AGENDA ITEM SUMMARY

SUBJECT: Consideration of an application for Preliminary Plat proposal for Sunburst Hills, a Cottage Townhouse Development, to be located at Lots 7-9, Block 62, within Woodside Sub #15 (2541, 2621, 2641 Winterhaven Drive) comprising of 1.78 acres. Current zoning of the property is General Residential. Proposed Preliminary Plat indicates a reconfiguration of existing Lots 7-9 to Lots 1-12, Sunburst Hills Subdivision.

TO: Hailey City Council
FROM: Micah Austin, Community Development Director
RE: Preliminary Plat – Sunburst Hills Subdivision
HEARING: Planning and Zoning: July 14, 2014
August 11, 2014
City Council: September 15, 2014

Figure 2. Proposed configuration of open space under Ordinance 4.10.1.1.

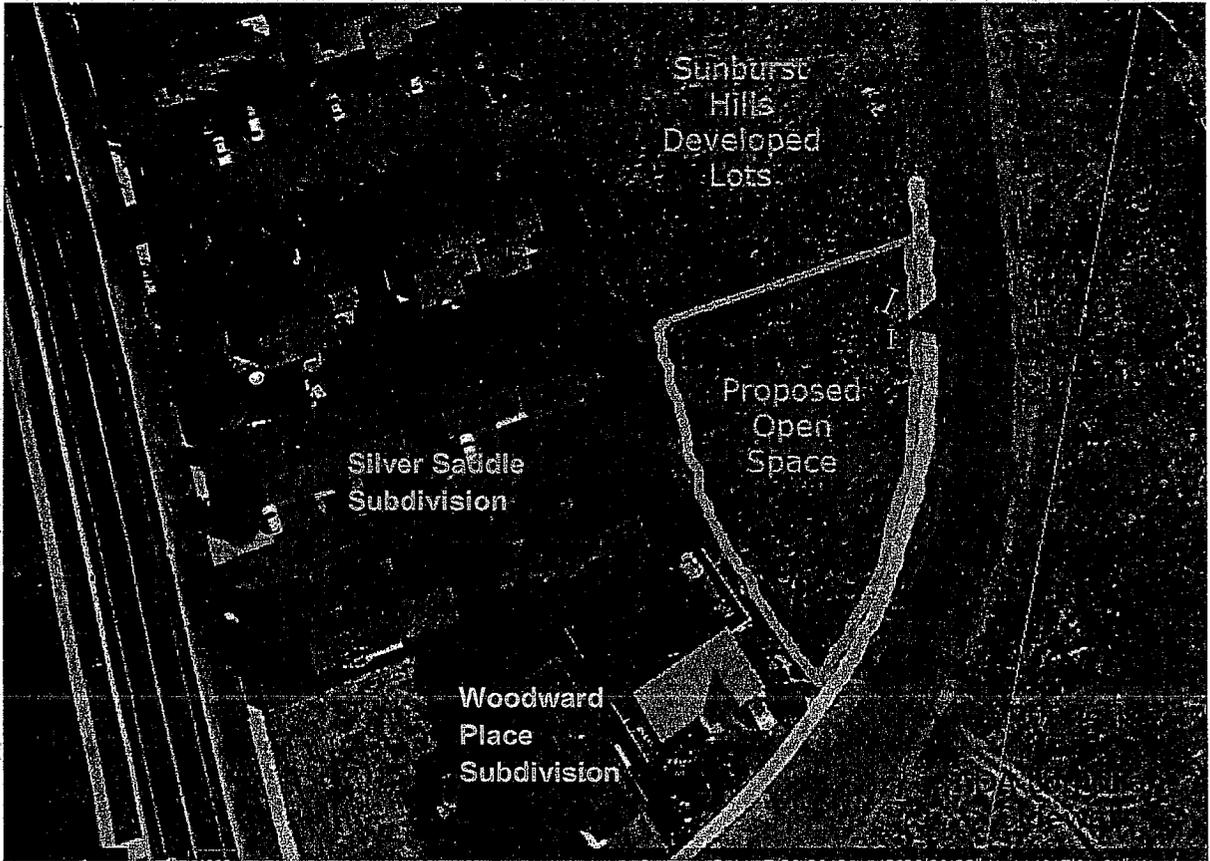
There are likely other means to accomplish a similar goal within the purview of the Ordinance, and I would be interested to hear any alternative that the Parks and Lands Board or the Commission may propose. However, the sketches below depict this simple and low cost concept that would be a win-win for all concerned. The existing single-family dwellings would be buffered from the new two-story development, the developer would be spared an in-lieu payment and need only make minimal adjustments to the preliminary plat, and the City would accomplish its mission without an added burden for park maintenance.
